HADLEY'S TOWING JSP16-33 with Rezoning 18.715

Public hearing at the request of Hadley's Towing for Planning Commission's recommendation to the City Council for rezoning of 5.6-acre of a 17.78-acre property in Section 17 on south side of Grand River Avenue between Wixom Road and Beck from I-1 (Light Industrial) to I-2 (General Industrial) with a Planned Rezoning Overlay (PRO). The subject property is approximately 17.78 acres and the applicant is proposing to rezone approximately 5.6 acres of northerly portion of the property to accommodate the vehicle towing business and storage yard. The rezoned area is proposed to be used as an enclosed storage yard for parking towed vehicles.

PLAN REVIEW CENTER REPORT

Review Date: September 13, 2016
Review Type: PRO Concept Plan
Project Name: JSP 16-33 Hadley's Towing
Plan Date: August 11, 2016
Prepared by: Sri Komaragiri, Planner
E-mail: skomaragiri@cityofnovi.org; **Phone:** (248) 735-5607

Figure 1. City of Novi Regulated Wetland & Woodland Map (approximate project area is highlighted in red). Regulated Woodland areas are shown in green and regulated Wetland areas are shown in blue).

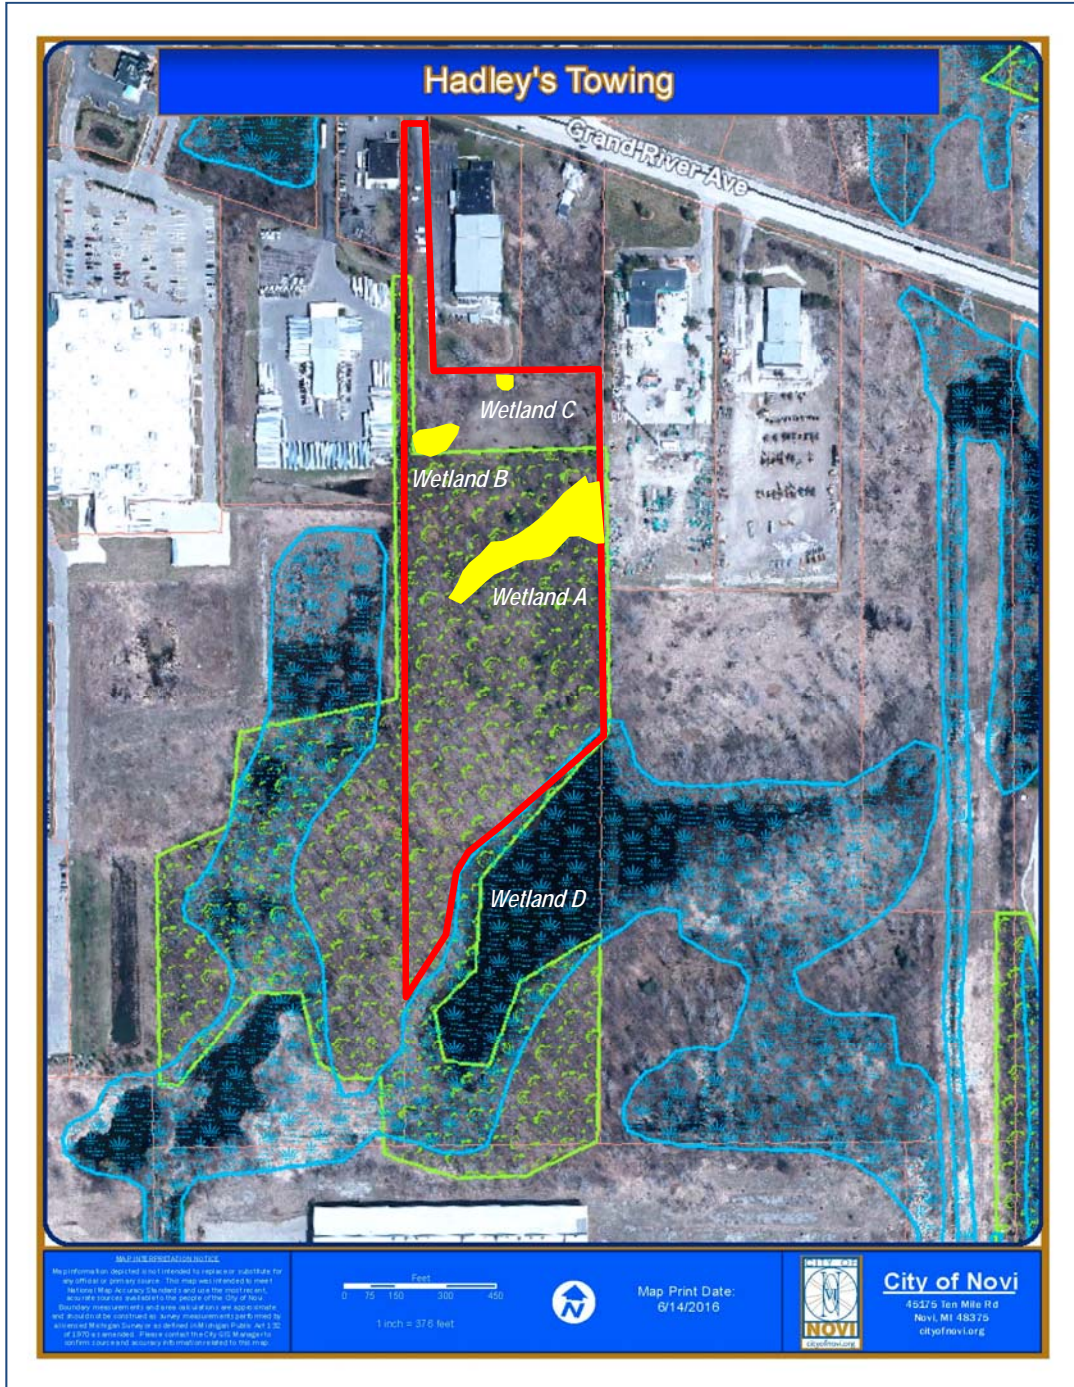
Based on our review of the Plan, Novi aerial photos, Novi GIS, the City of Novi Official Wetlands and Woodlands Maps (see Figure 1, attached) it appears as if this proposed project site contains City-regulated wetlands and woodlands. The City's wetland and woodland map shows that the overall property contains wetlands to the south. However, a review of aerial photos of the site, the proposed site plan, and previous site visits, the site contains four (4) total areas of wetland (Wetlands A, B, C, and D).

Wetland A is a scrub/shrub wetland located south of the proposed development area. Wetland B is an emergent wetland located in the western area of the site, adjacent to the existing CZ Trucking storage/parking area. Wetland C is an emergent wetland located central to the proposed development along the northern boundary. Approximate wetland locations (Figure 1) as well as site photos are attached.

Figure 1. City of Novi Regulated Wetland & Woodland Map (approximate project area is highlighted in red). Regulated Woodland areas are shown in green and regulated Wetland areas are shown in blue).

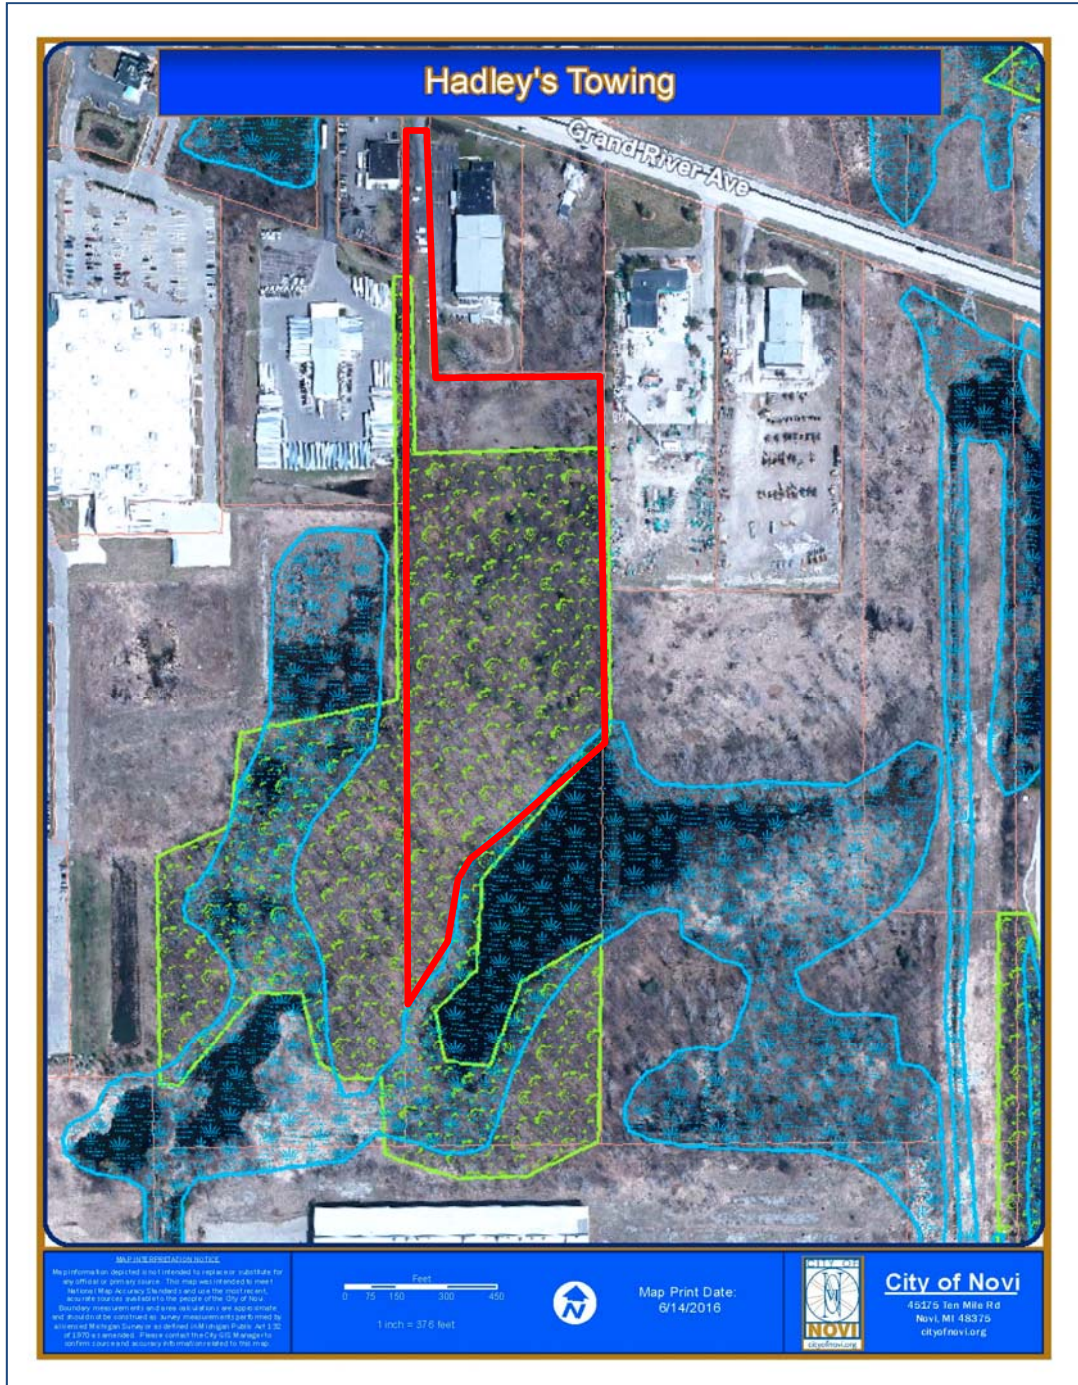
The site does contain areas noted as City of Novi Regulated Woodlands. The majority of the property contains Regulated Woodland (see Figure 1). The current plan includes a partial tree list and a partial list of the proposed tree removals. The plan notes that "*tree survey to be performed on south portion of property at the time of preliminary site plan submittal*".
